Camberwell Old Cemetery, Southwark

Plot Z Drainage Strategy Review

Southwark Council

October 2016

C	Scale note	BB	PH
REV:	description:	dwn:	chkd:
		date:	date:
Project:			
Area Z			
drawing:			
Illustrative Drainage Strategy Layout			
client:			
Southwark Council -			
scale(s):	date:	drawn by:	checked:
:250 @ A1	20.04.15	AJDP	PH
drawing number:	048-07-24		
xrefs:	status:	rev:	
-	PLANNING	C

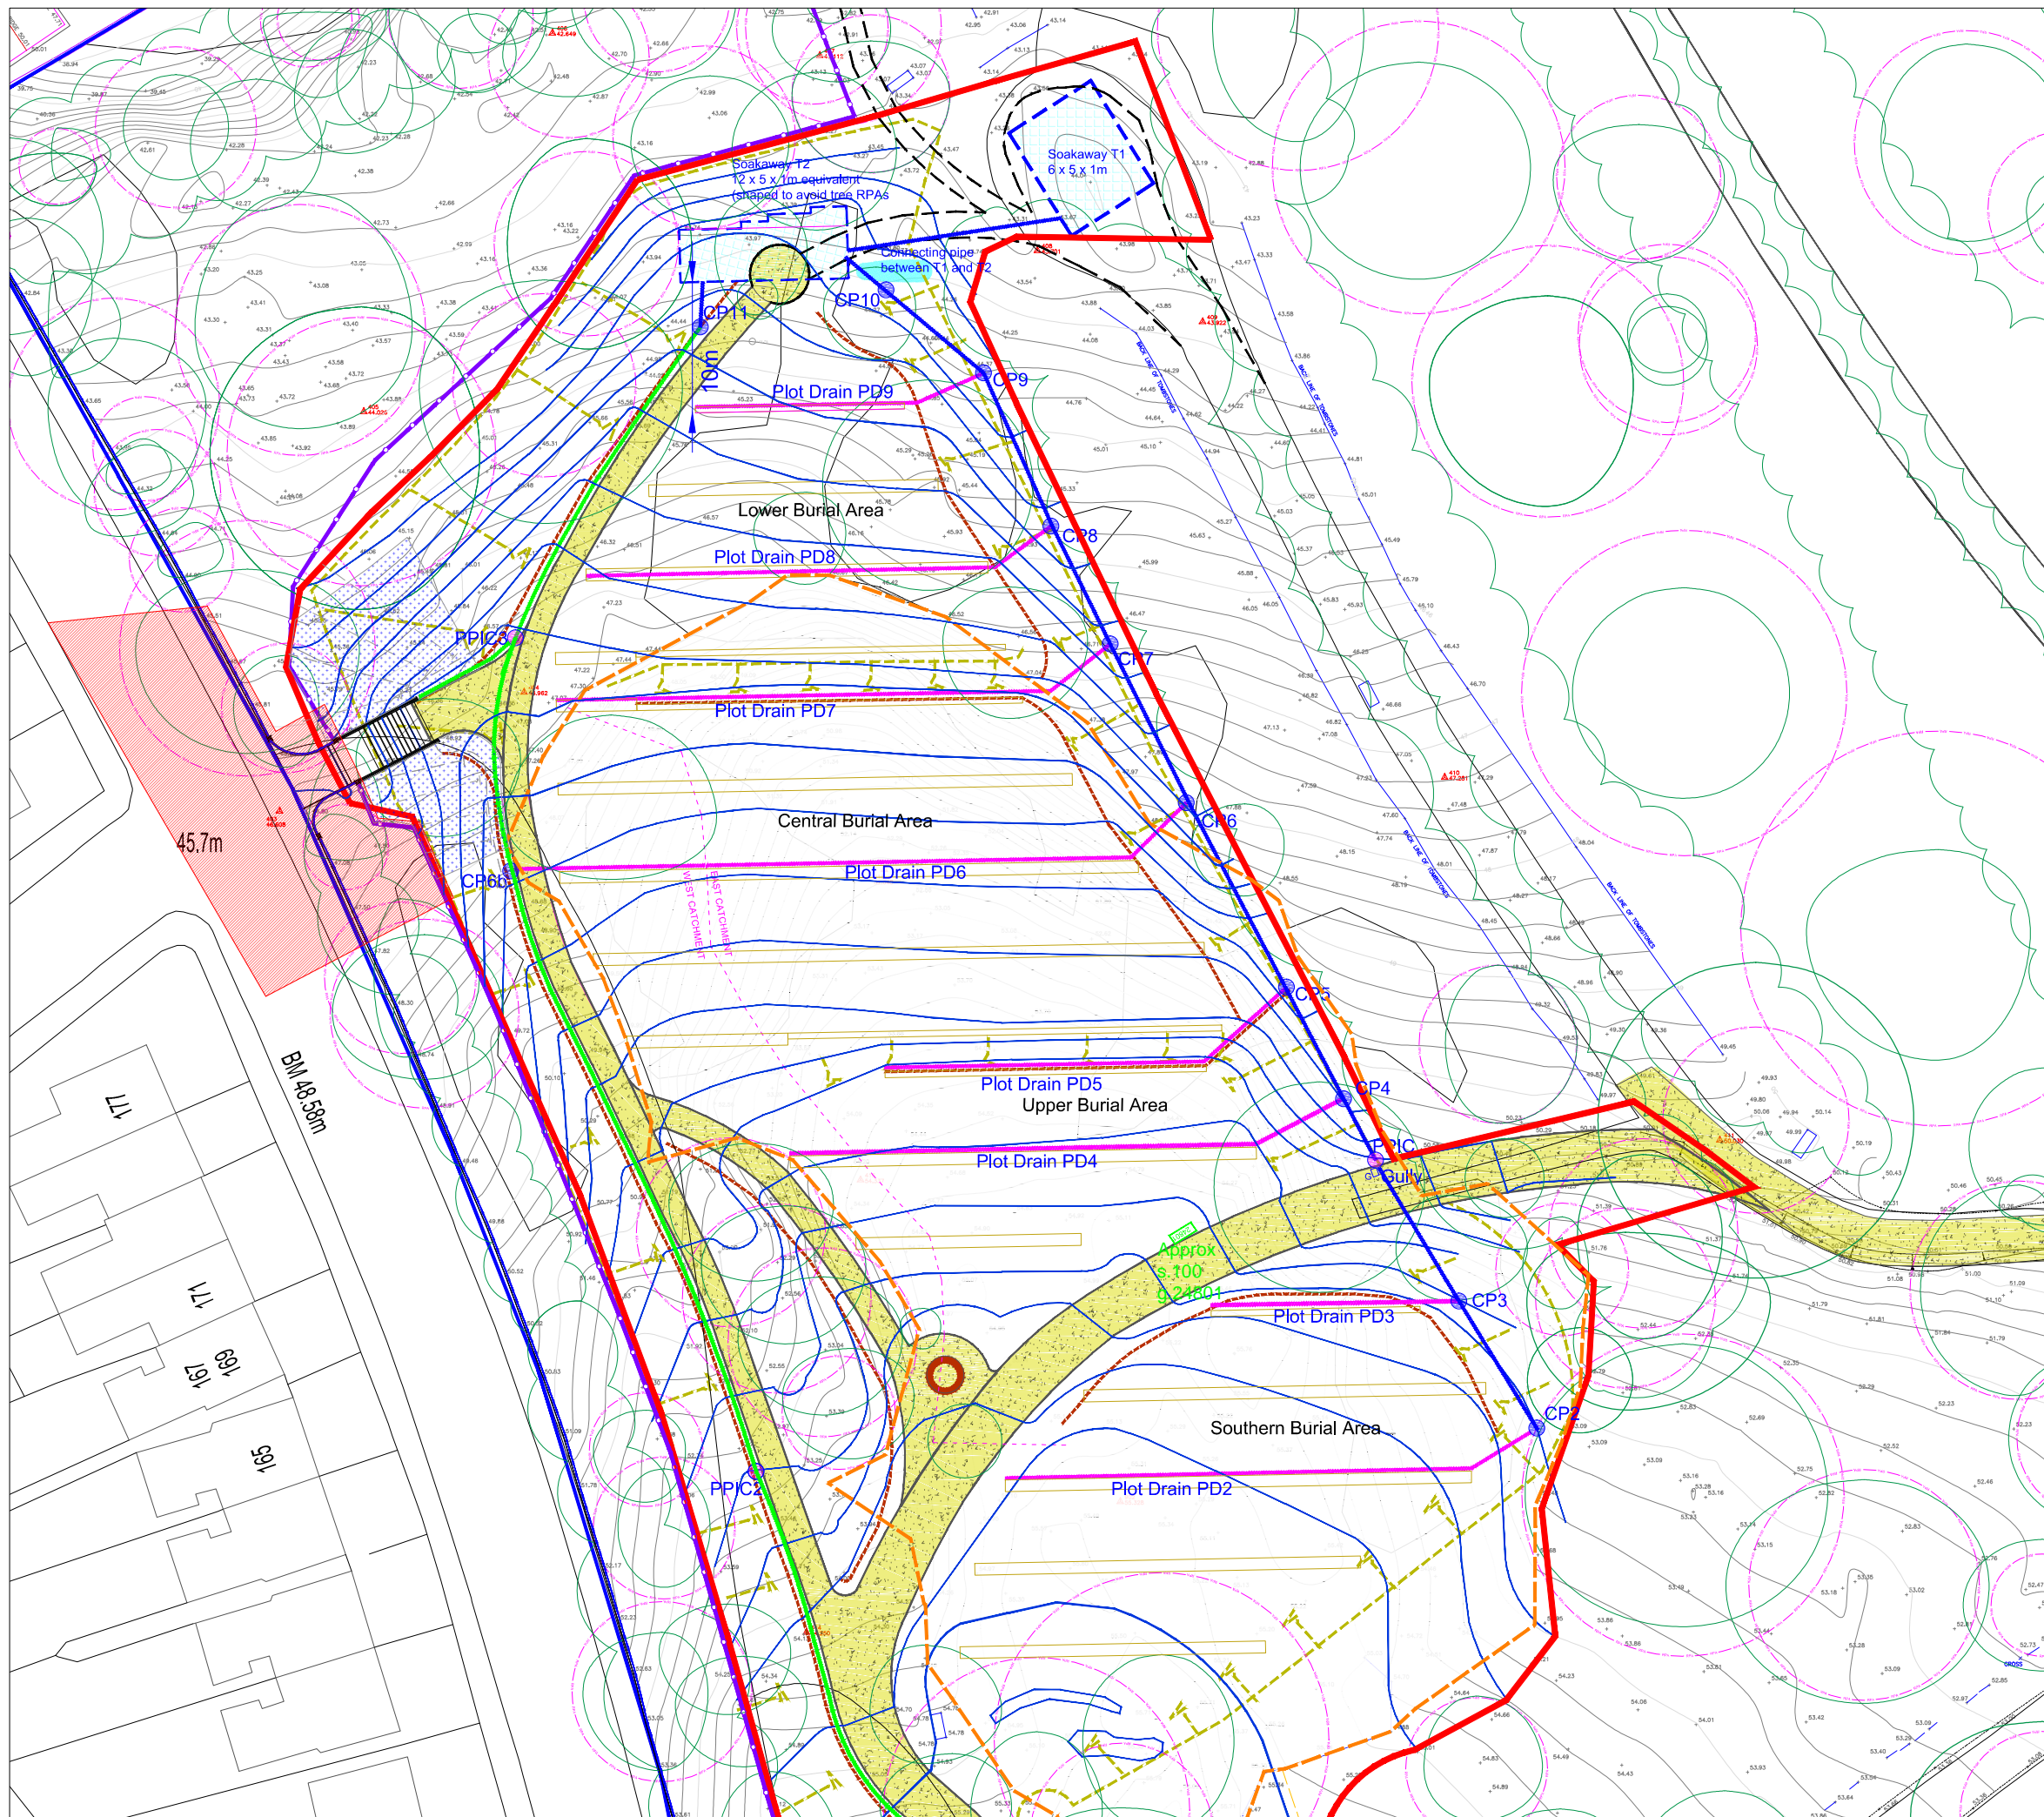
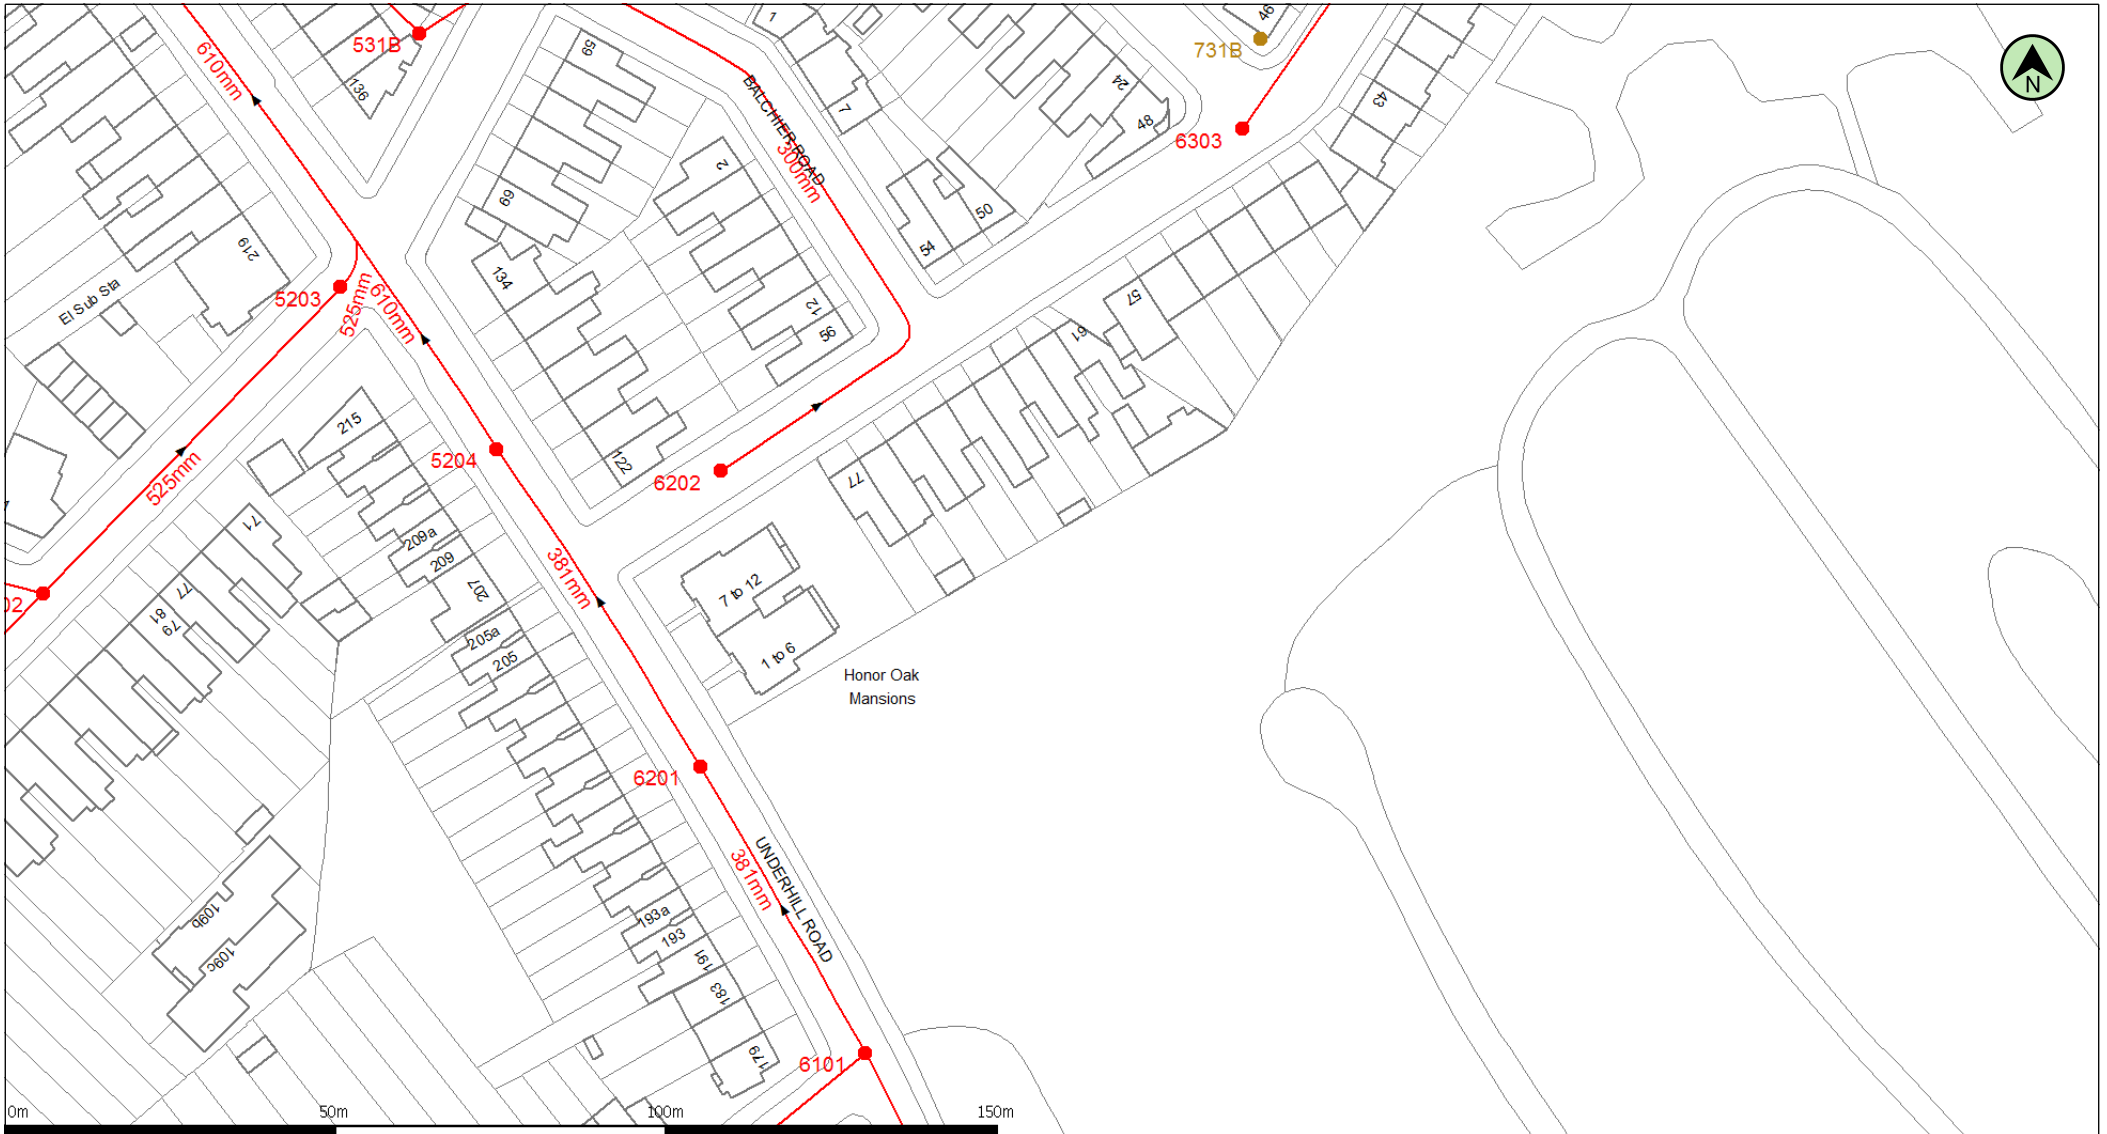
2.2.4 The map on the last page of the plan, prepared by Harrison Design, shows a drop of at least 5m over a distance of less than 40 metres between the top of soakaway 2 and the visible part of Ryedale (which in fact continues to fall all the way to Forest Hill Road). BSP do not mention any flood safety implications of siting a soakaway on a bank. Do you think there are any?

2.2.5 The map also shows extended contours on the downhill side of soakaway 2. Do you agree that part of the tank is therefore contained in an artificial mound. No mention of this is made by BSP. Would you want to see tests carried out on the possibility of a full tank breaching and flooding the back gardens beyond the end of, and below the level of, the retaining wall below?

- a) Detailed geotechnical and hydrological testing and analysis, as well as slope analysis should be undertaken as part of the detailed design to determine if siting the soakaway in this location is likely to induce failure of the slope.

- a) The depth of the soakaway and construction methodology of the raised ground should be clarified to make sure the infiltration from the soakaway does not affect the integrity of the slope.
- b) Should the soakaways flood in extreme storm events it is considered the topography of the wider site will direct surface water to the north east area of the site and pond in this area. As part of the detailed design measures should be undertaken to make sure this flood routing is retained.
